# Access Compliance Report

## Public Rights-of-Way (Curb Ramps)

Intersection ID: 6107	Main Street: HAMPTON_CHURCH_RD	Cross Street: N_TRYON_ST	Location: NE
ADA ID: E15B6BB63E91	Ramp Type: Directional1	Initial Pass/Fail: Fail	Overall Compliance: No
		Severity Score: 1.25

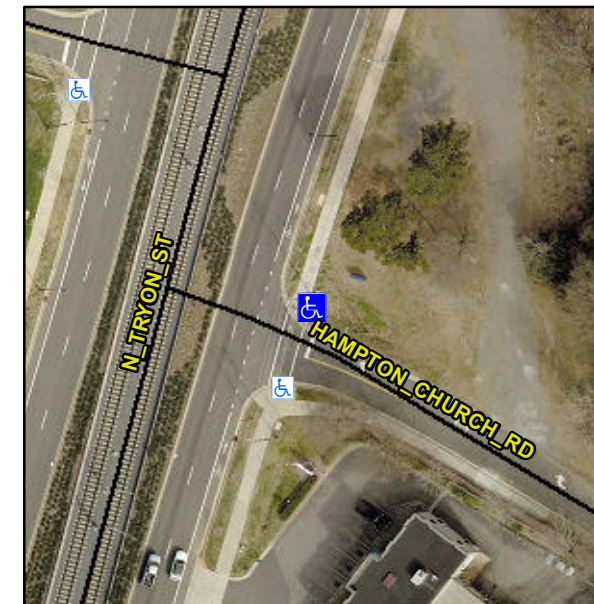
**R304.5.3**

Compliance	Description	Data	Compliance	Description	Data
N/A	Ramp Length (in)	88.0	N/A	Grade Break?	N/A
Yes	Ramp Width (in)	96.0	N/A	Grade Break Slope (%)	0.0
Yes	Ramp Slope (%)	4.5	N/A	Grade Break XSlope (%)	0.0
No	Ramp XSlope (%)	3.2			
N/A	Flare Type LT	N/A	N/A	Flare Type RT	N/A
N/A	Flare Slope LT (%)	N/A	N/A	Flare Slope RT (%)	0.0
N/A	Flare Traversable LT?	N/A	N/A	Flare Traversable RT?	N/A
N/A	Landing Length (in)	0.0	N/A	DWS Provided?	N/A
N/A	Landing Width (in)	0.0	N/A	DWS Contrast?	N/A
N/A	Landing Slope (%)	0.0	N/A	DWS Length (in)	N/A
N/A	Landing X Slope (%)	0.0	N/A	DWS Full Width?	N/A
N/A	Landing Curb? (Y/N)	N/A	N/A	DWS Offset LT (in)	N/A
N/A	Shared Landing?	N/A	N/A	DWS Offset RT (in)	N/A
N/A	Gutter Ponding?	0.0	N/A	Gutter Slope (%)	N/A
N/A	Gutter Lip Ht (in)	0.0	N/A	Gutter X Slope (%)	N/A
N/A	Painted X Walk1?	Yes		Road Slope (%)	2.2
	X Walk 1 Direction	To S		Road X Slope (%)	3.2
	X Walk 1 Width (in)	115.0		Clear Space?	N/A

X Walk 1 Slope (%)	2.2	N/A	Clear Space to XWalk (in)	N/A
	X Walk 1 X Slope (%)	3.2	N/A	Storm Grate/Utility Hazard?	N/A
N/A	Ramp inside XWalk1?	Yes		Storm Grate/Utility Type	
N/A	Any Obstructions?	N/A			N/A
	Obstruction Type		Yes	Surface Condition? (G/P)	Good
			N/A	Curb Slope (%)	5.0

**Remove & Replace Entire Ramp.**
